**Economic and Social Council**Distr.: General
26 September 2013

World Forum for Harmonization of Vehicle Regulations**Working Party on Passive Safety****Fifty-fourth session**

**Regulation No. 127 (Pedestrian safety) - Proposal for the 01 series
of amendments to Regulation No. 127****Proposal of 01 series of amendments to Regulation No. 127****Submitted by the experts from the informal working group
on global technical regulation No. 9 Phase 2***

The text reproduced below was prepared by the experts from the informal working group on global technical regulation No. 9 Phase 2 (GTR9-PH2) proposing provisions on pedestrian protection of motor vehicles. The modifications to the text of the UN Regulation are marked in bold for new or strikethrough for deleted characters.

"Figure 1

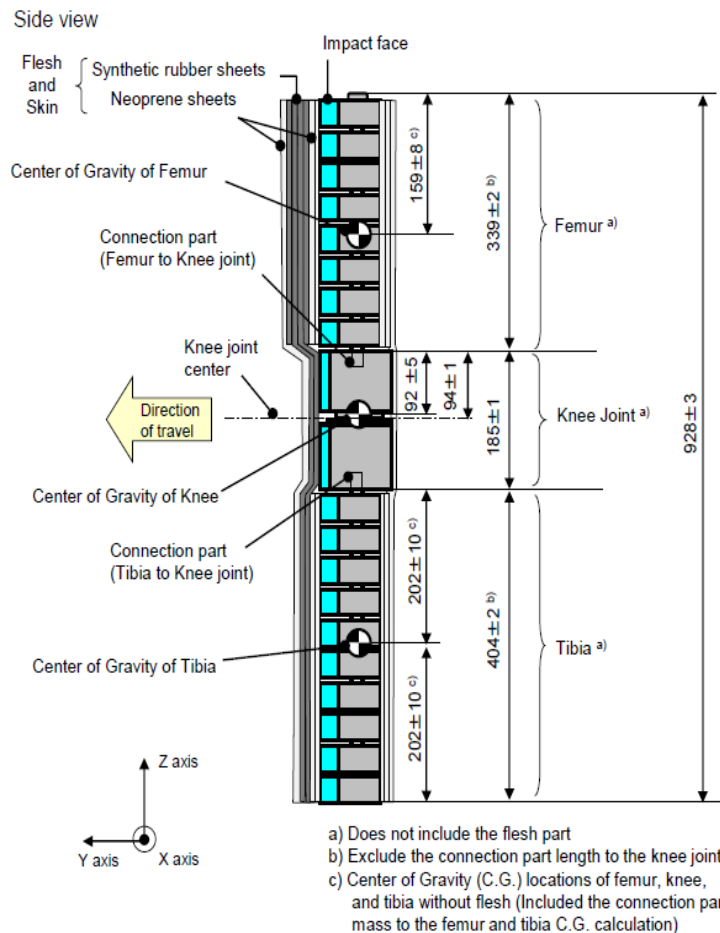
- The flexible lower legform impactor shall consist of flesh and skin, flexible long bone segments (representing femur and tibia), and a knee joint as shown in Figure 1. The assembled impactor shall have a total mass of $13.2 \pm [0.7$ kg]. The dimensions of the fully assembled impactor shall be as defined in Figure 1.**

The centres of gravity of the femur and tibia without the flesh and skin, including the connection parts to the knee joint, shall be as defined in Figure 1. The centre of gravity of the knee joint shall be as defined in Figure 1.

Figure 2
Flexible lower legform impactor schematic plan views of femur, tibia, and knee
dimensions (top view)

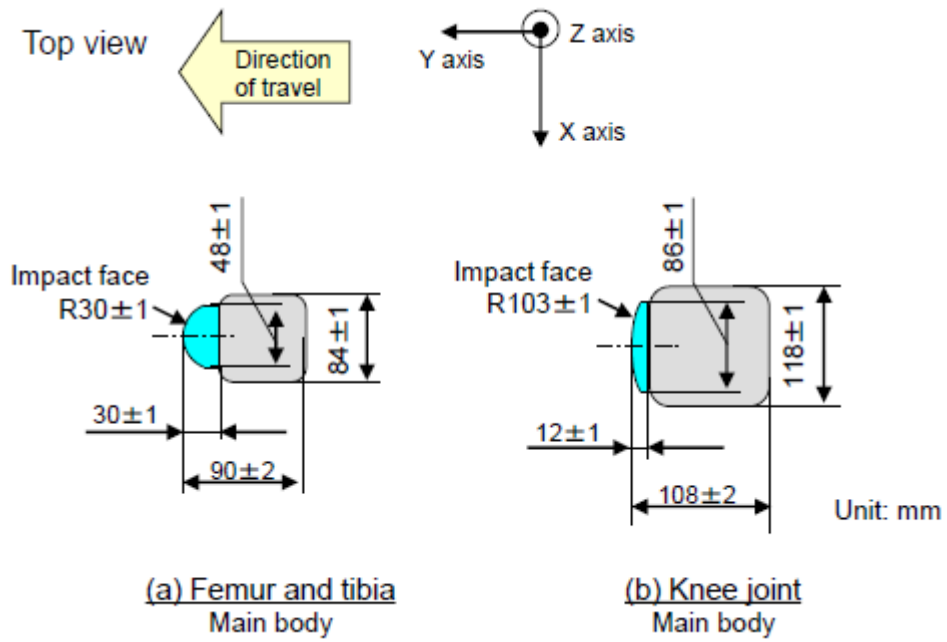
with 0.5 mm thick nylon cloth on both sides, with an overall thickness of 6 mm. The cross-sectional shape of the femur main body segments, the tibia main body segments and their impact faces shall be as defined in Figure 2(a).

- 1.3. ~~The knee joint shall be fitted with deformable knee elements from the same batch as those used in the certification tests.~~ **The cross-sectional shape of the knee joint and its impact face shall be as defined in Figure 2 (b).**

Figure 3
Flexible lower legform impactor instrument locations

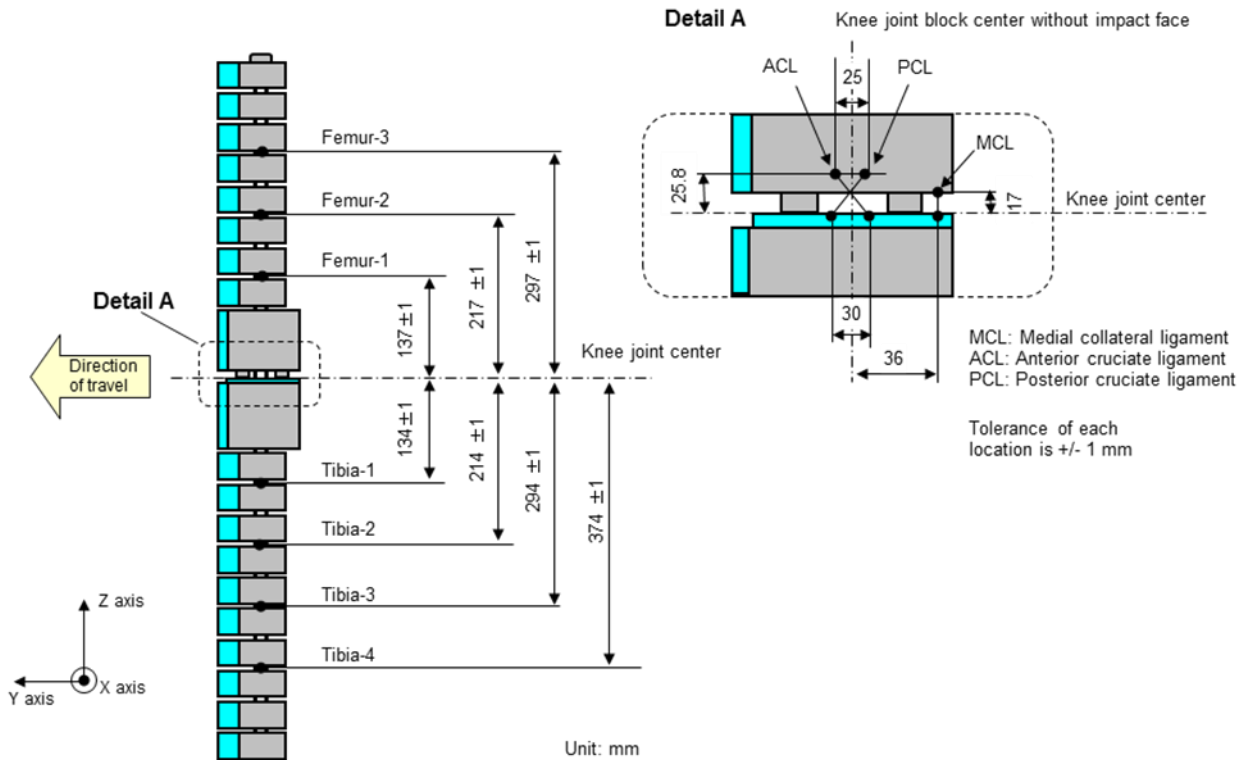
- "2.1. ~~An uniaxial accelerometer shall be mounted on the non impacted side of the tibia, 66 ± 5 mm below the knee joint centre, with its sensitive axis in the direction of impact.~~ **Four transducers shall be installed in the tibia to measure bending moments at the locations within the tibia. Three transducers shall be installed in the femur to measure bending moments applied to the femur. The sensing locations of each of the transducers are as defined in Figure 2. The measurement axis of each transducer shall be the X-axis of the impactor.**

- 2.2. ~~A damper shall be fitted to the shear displacement system and may be mounted at any point on the rear face of the impactor or internally. The damper properties shall be such that the impactor meets both the static and dynamic shear displacement requirements and prevents excessive vibrations of the shear displacement system.~~ **Three transducers shall be installed in the knee joint to measure elongations of the medial collateral ligament (MCL), anterior cruciate ligament (ACL), and posterior cruciate ligament (PCL). The measurement locations of each transducer are shown in Figure 3. The measurement locations shall be within ± 4 mm along the X-axis from the knee joint centre.**

"Figure 1
Flexible lower legform impactor: Flesh and skin dimensions

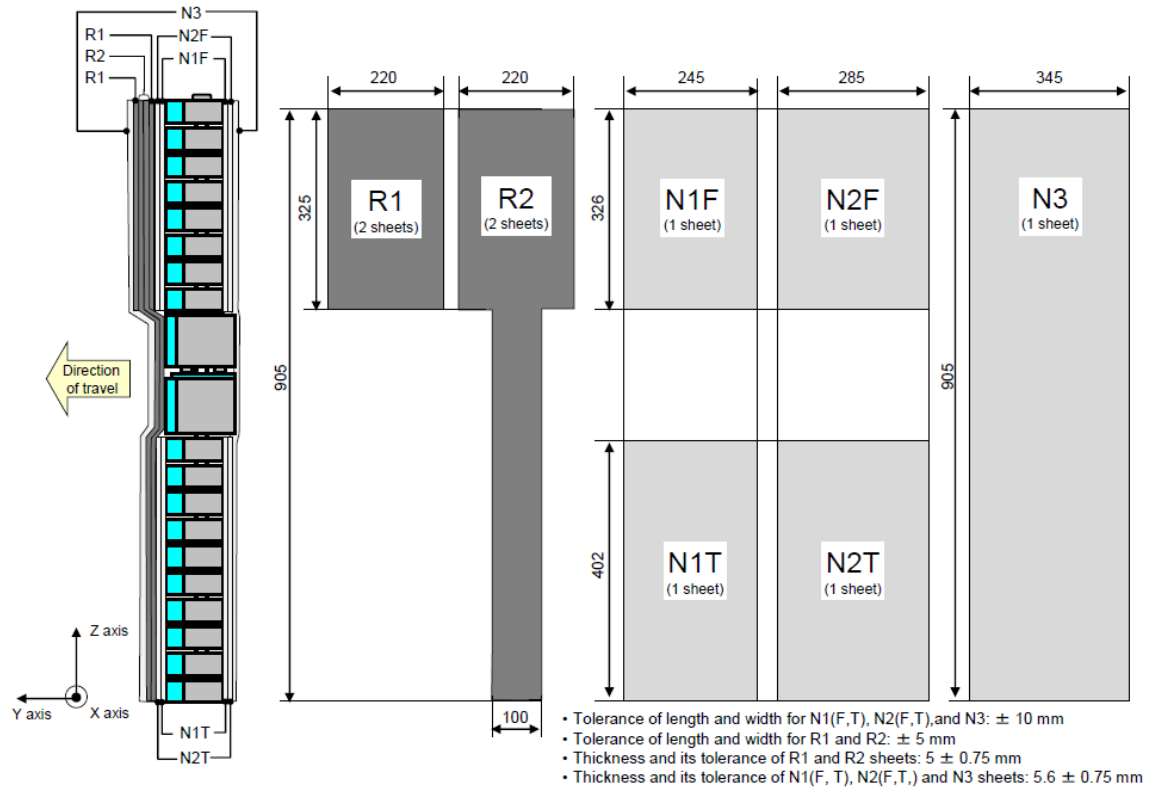
1.1. For each test the impactor ~~shall be fitted with new foam flesh cut from one of up to four consecutive sheets of foam type CF 45 flesh material or equivalent, produced from the same batch of manufacture (cut from one block or "bun" of foam), provided that foam from one of these sheets was used in the dynamic certification test and the individual weights of these sheets are within ± 2 per cent of the weight of the sheet used in the certification test.~~ **(femur, knee joint and tibia) shall be covered by flesh and skin composed of synthetic rubber sheets (R1, R2) and neoprene sheets (N1F, N2F, N1T, N2T, N3) as shown in Figure 1. The size of the sheets shall be within the requirements described in Figure 1. The sheets are required to have compression characteristics as shown in Figure 2. The compression characteristics shall be checked using material from the same batch as the sheets used for the impactor flesh and skin.**

Figure 2
Flexible lower legform impactor: Flesh and skin compression characteristics

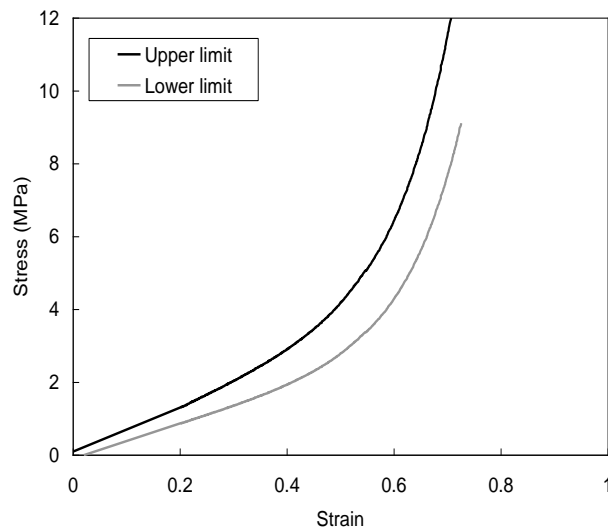
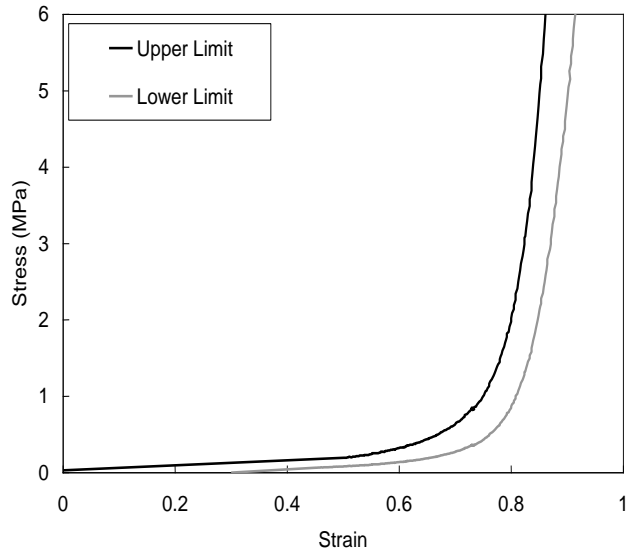
removed. The neoprene sheet used in this test shall have compression characteristics as shown in Figure 2 (b) of Annex 5.

"Figure 43

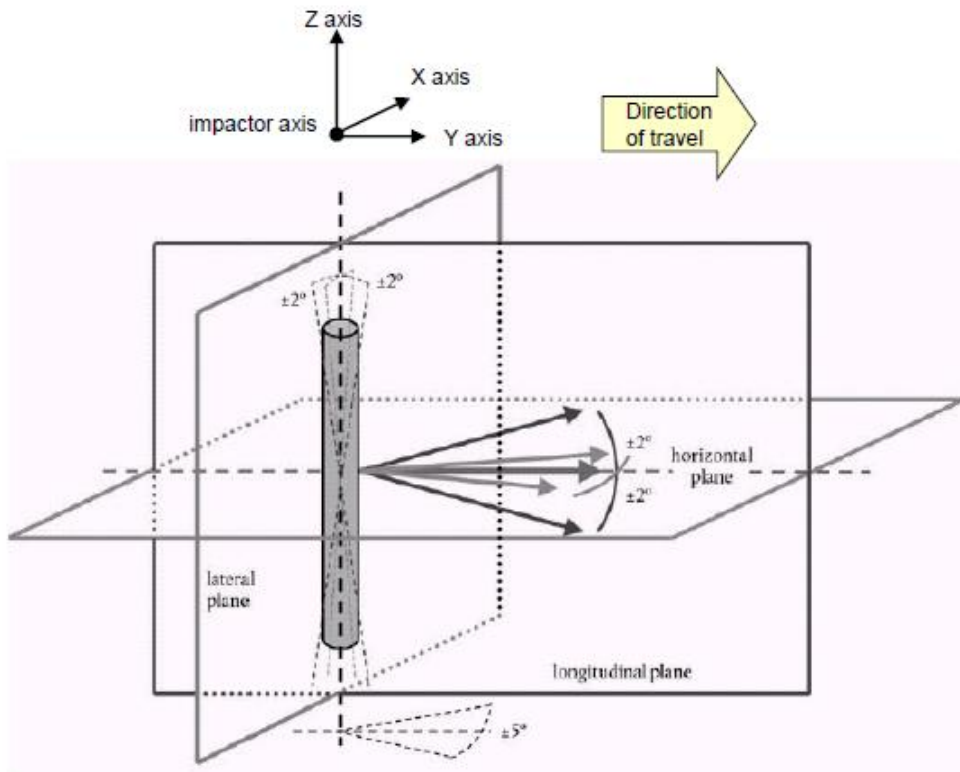
"1.6. The direction of the impact velocity vector shall be in the horizontal plane and parallel to the longitudinal vertical plane of the vehicle. The tolerance for the direction of the velocity vector in the horizontal plane and in the longitudinal plane shall be $\pm 2^\circ$ at the time of first contact. The axis of the impactor shall be perpendicular to the horizontal plane with a **roll and pitch angle** tolerance of $\pm 2^\circ$ in the lateral and longitudinal plane. The horizontal, longitudinal and lateral planes are orthogonal to each other (see Figure 43).

- 1.9. At the time of first contact the impactor shall have the intended orientation about its vertical axis, for the correct operation of its knee joint, with a **yaw angle** tolerance of $\pm 5^\circ$ (see Figure 43)."

"Figure 2 4

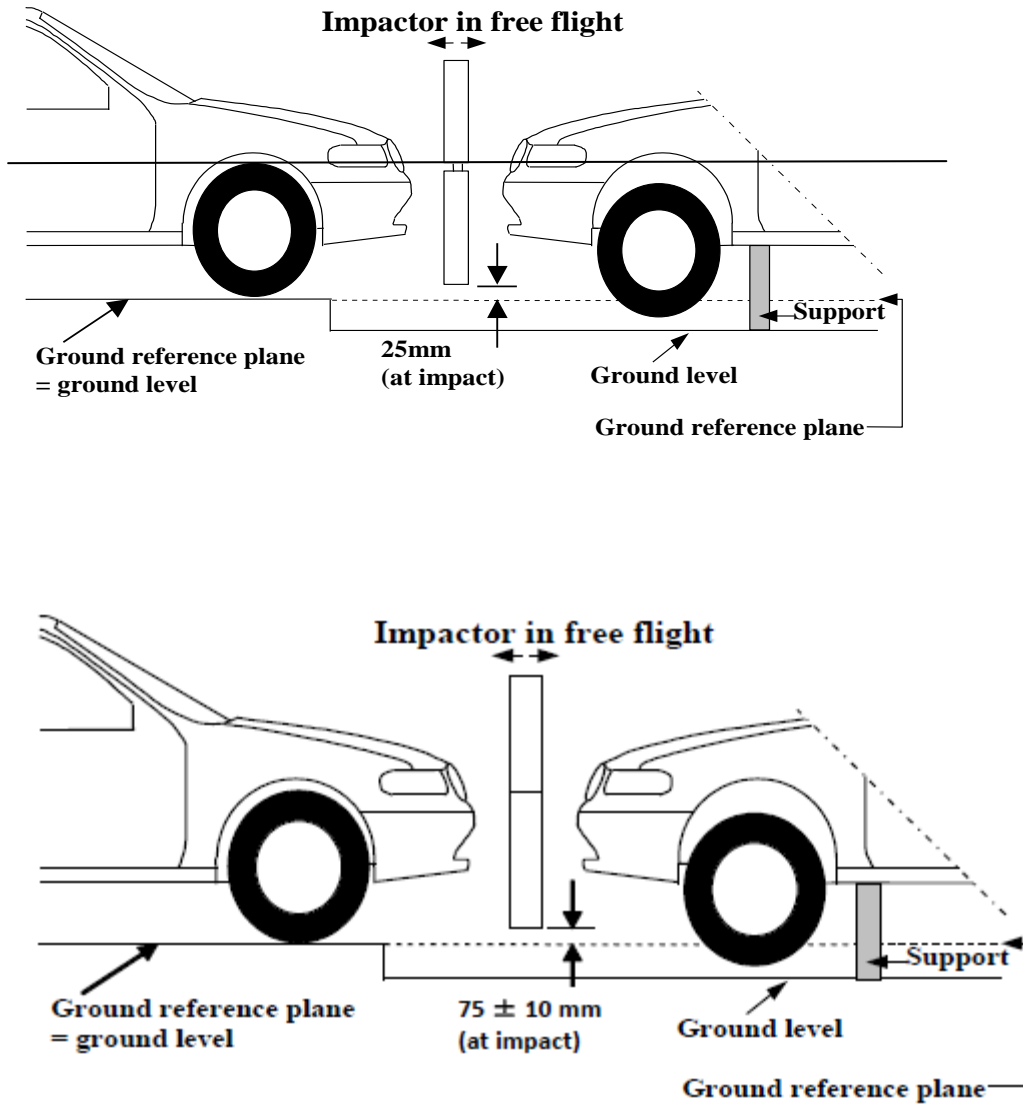
1.7. The bottom of the impactor **(without parts needed for the purposes of launching and/or protection)** shall be at ~~25~~ **75** mm above ground reference plane at the time of first contact with the bumper (see Figure 24), with a ± 10 mm tolerance. When setting the height of the propulsion system, an allowance must be made for the influence of gravity during the period of free flight of the impactor.

Flexible lower legform impactor: Requirement corridors of the femur and the tibia in the static certification test (see paragraph 1.2.2. of this Annex)

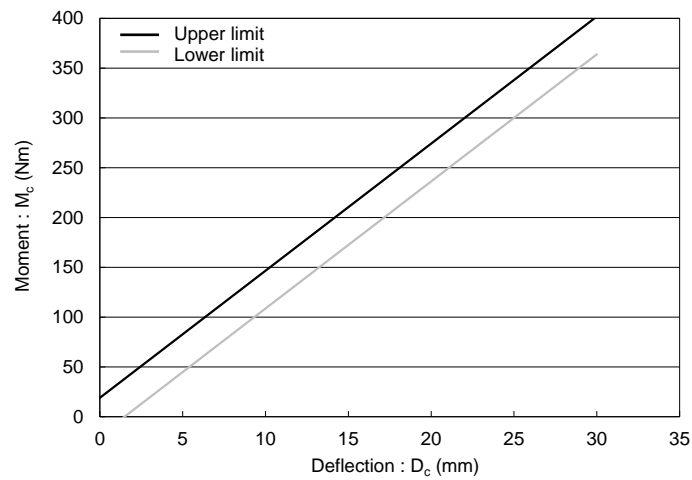
- 1.2.2. **When the femur and the tibia of the impactor are loaded in bending in accordance with paragraph 1.2.4., the applied moment and the generated deflection at the centre of the femur and the tibia (M_c and D_c) shall be within the corridors shown in Figure 1.**

Figure 2
Flexible lower legform impactor: Requirement corridors for the knee joint in the static certification test (see paragraph 1.2.3. of this Annex)

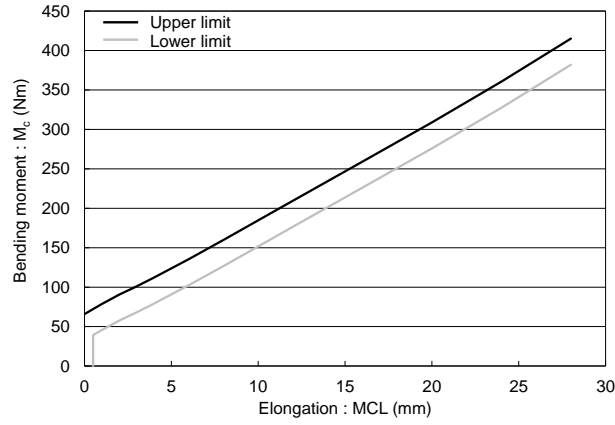
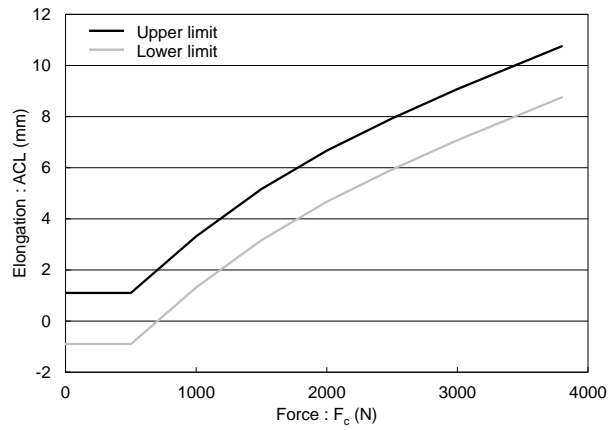
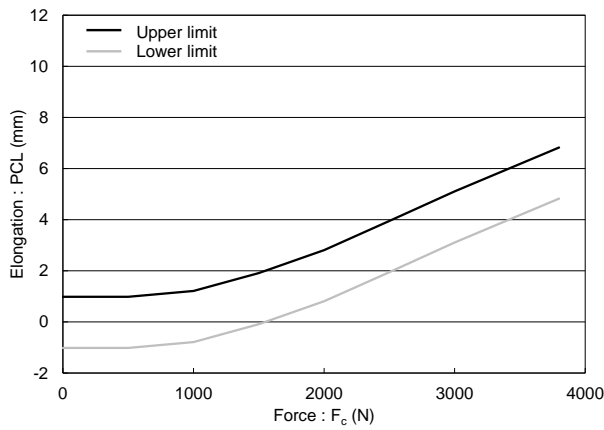
- 1.2.3. **When the knee joint of the impactor is loaded in bending in accordance with paragraph 1.2.5 of this Annex, the MCL, ACL, and PCL elongations and applied bending moment or the force at the centre of the knee joint (M_c or F_c) shall be within the corridors shown in Figure 2.**

Figure 3
Flexible lower legform: Impactor test set-up for the femur in the static certification test (see paragraph 1.2.4. of this Annex)

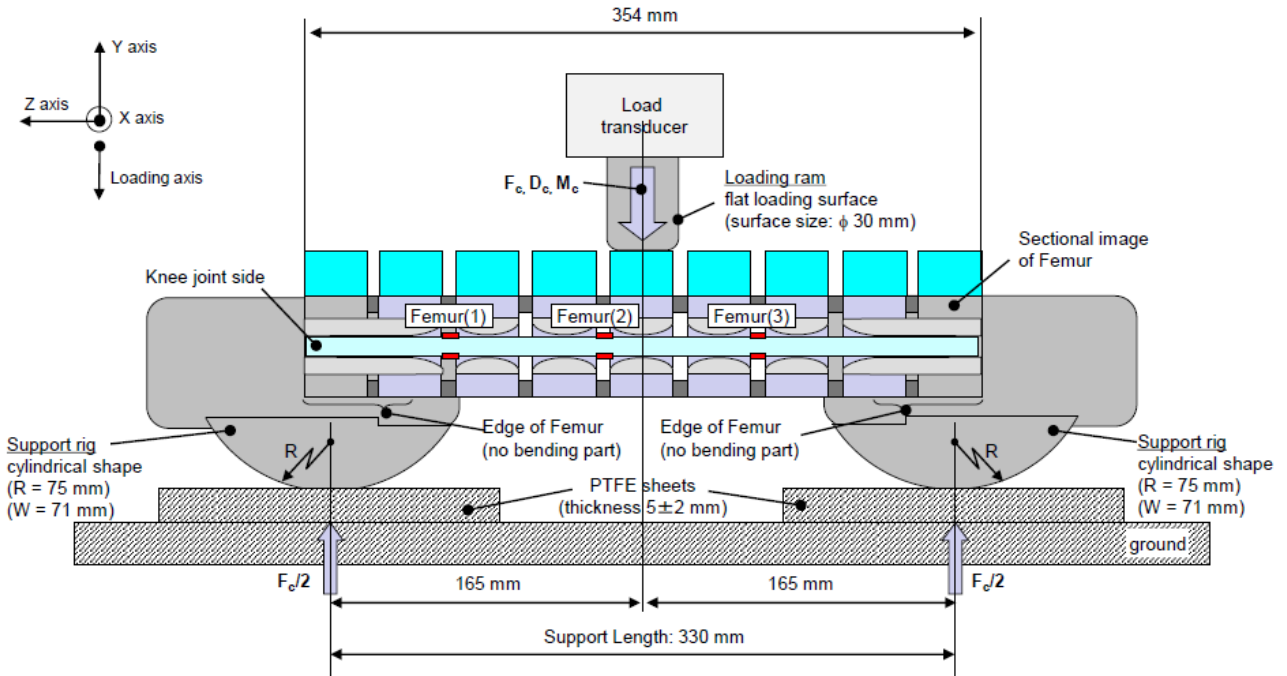
- 1.2.4. **The edges of the femur and tibia, not bending parts, shall be mounted to the support rig firmly as shown in Figure 3 and Figure 4. The Y-axis of the impactor shall be parallel to the loading axis within $180 \pm 2^\circ$ tolerance. To obtain repeatable loading, low friction Polytetrafluoroethylene (PTFE) plastic pads are used under each support (see Figure 3 and Figure 4).**

The centre of the loading force shall be applied at the centre of the femur and the tibia within ± 2 mm tolerance along the Z-axis. The force shall be increased so as to maintain a deflection rate between 10 and 100 mm/minute until the bending moment at the centre part (M_c) of the femur or tibia reaches 380 Nm.

Figure 5
Flexible lower legform impactor: Test set-up for the knee joint in the static certification test (see paragraph 1.2.5.)

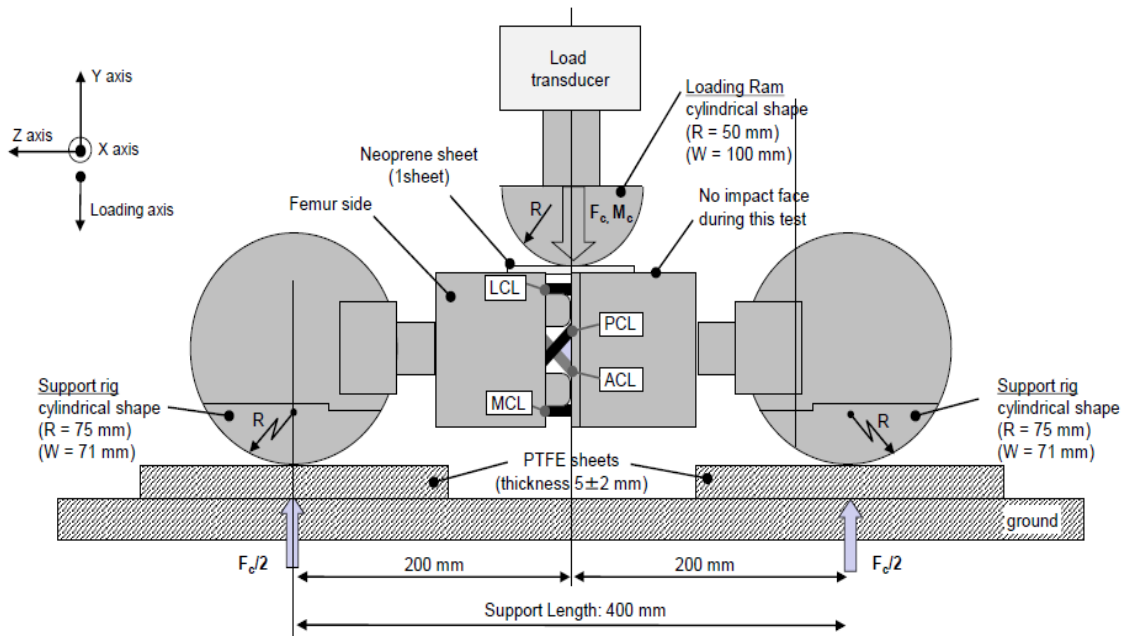
- 1.2.5. **The ends of the knee joint shall be mounted to the support rig firmly as shown in Figure 5. The Y-axis of the impactor shall be parallel to the loading axis within $\pm 2^\circ$ tolerance. To obtain repeatable loading, low friction Polytetrafluoroethylene (PTFE) plastic pads are used under each support (see Figure 5). To avoid impactor damage, a neoprene sheet shall be set underneath the loading ram and the impactor face of the knee joint which is described in the Figure 3 (b) of Annex 4 shall be**

The centre of the loading force shall be applied at the knee joint center within ± 2 mm tolerance along the Z-axis (see Figure 5). The external load shall be increased so as to maintain a deflection rate between 10 and 100 mm/minute until the bending moment at the centre part of the knee joint (M_c) reaches 400 Nm.

Figure 6
Flexible lower legform impactor: Test set-up for the dynamic lower legform impactor certification test (pendulum test, see paragraph 1.3.3.1.)

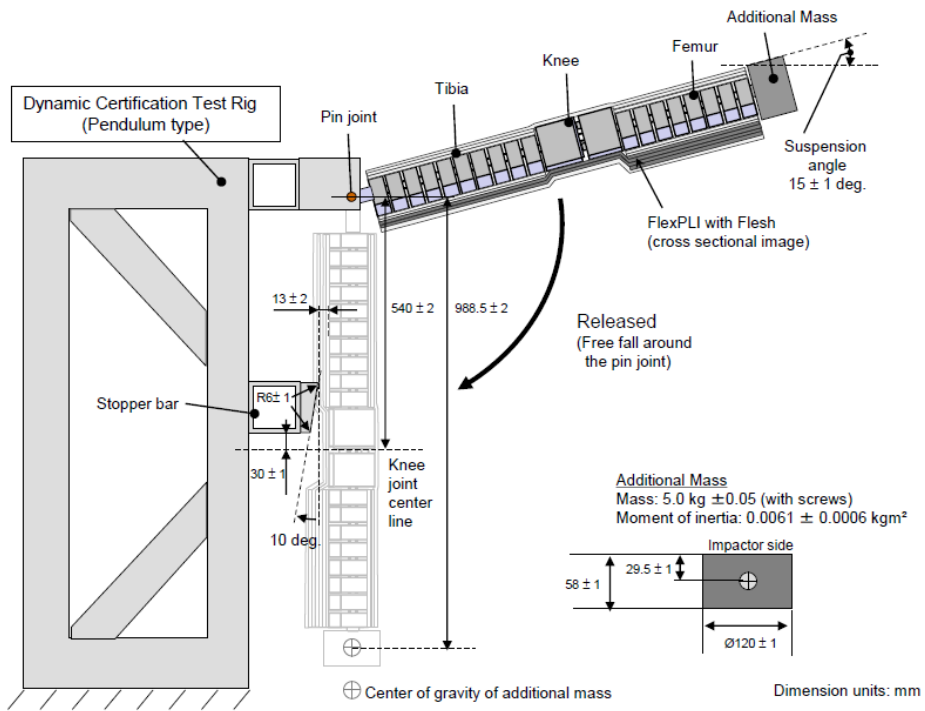
- 1.3.3.1. **The flexible lower legform impactor, including the flesh and skin, shall be suspended from the dynamic certification test rig $15 \pm 1^\circ$ upward from the horizontal as shown in Figure 6. The impactor shall be released from the suspended position and fall freely against the pin joint of the test rig as shown in Figure 6.**

- 1.3.3.2. **The knee joint centre of the impactor shall be 30 ± 1 mm below the bottom line of the stopper bar, and the tibia impact face without the flesh and skin shall be located 13 ± 2 mm from the front upper edge of the stopper bar when the impactor is hanging freely as shown in Figure 6.**
